DOCKET ITEM #14
Development Special Use Permit #2015-0002
Transportation Management Plan SUP #2015-0057
3640 Wheeler Avenue – EZ Storage

Purpose of Application
Approval of a Development Special Use Permit with site plan and modifications to construct a storage facility.

Figure 1: Impervious Area in RPA (Existing & Proposed)

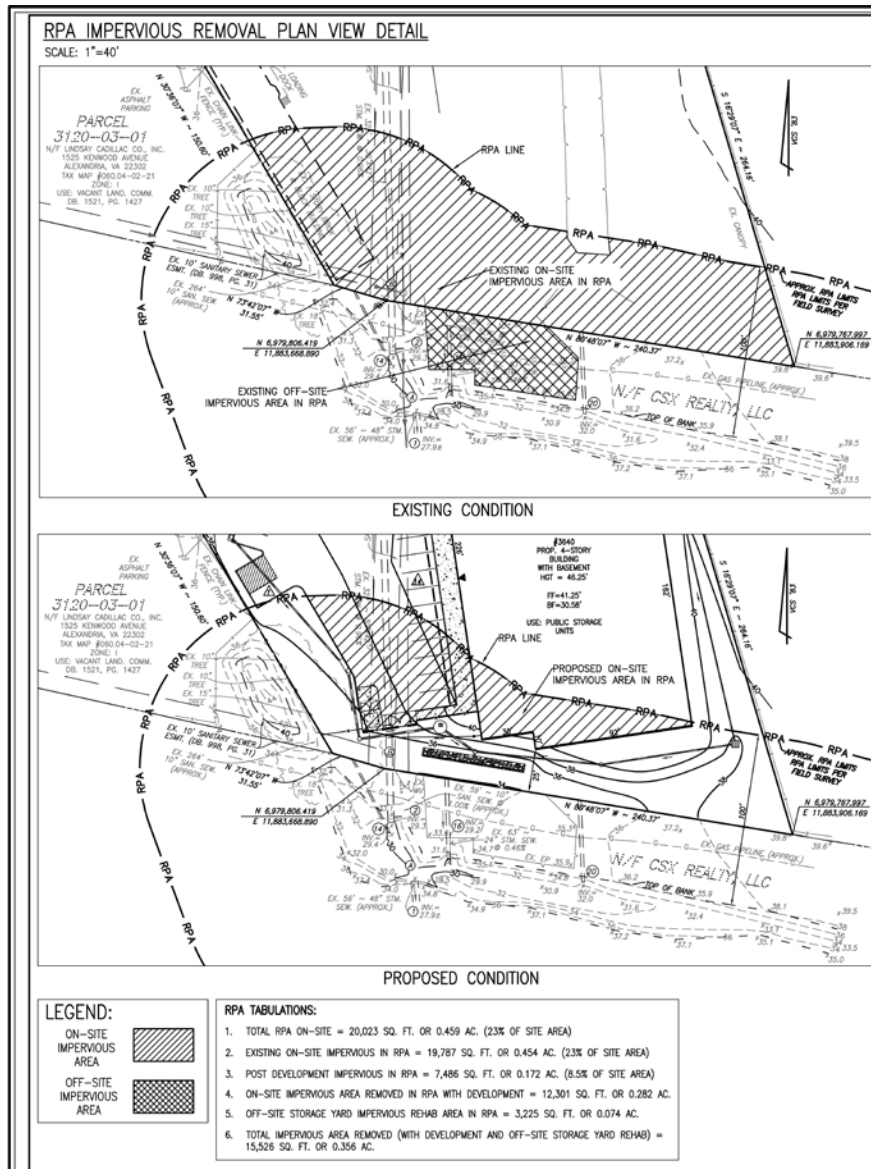
There is an existing Resource Protection Area (RPA) in the southern portion of the site. Currently, pavement covers the entire RPA area that lies within the property boundaries. During the conceptual design process, staff worked closely with the applicant to reconfigure a portion of the proposed parking area to eliminate impervious surface from the RPA. The reconfiguration resulted in fewer parking spaces, and allowed for planting of 3 large shade trees in the RPA. Figure 1 below illustrates the reduction of pervious area from the RPA that can occur based on the requested parking reduction. It's important to note that the new building is permitted in the RPA on this site because the existing impervious parking area pre-dates the formation of the RPA in 1992. Under these circumstances, the impervious area within the RPA boundary is considered a grandfathered encroachment into the RPA under the Chesapeake Bay regulations.
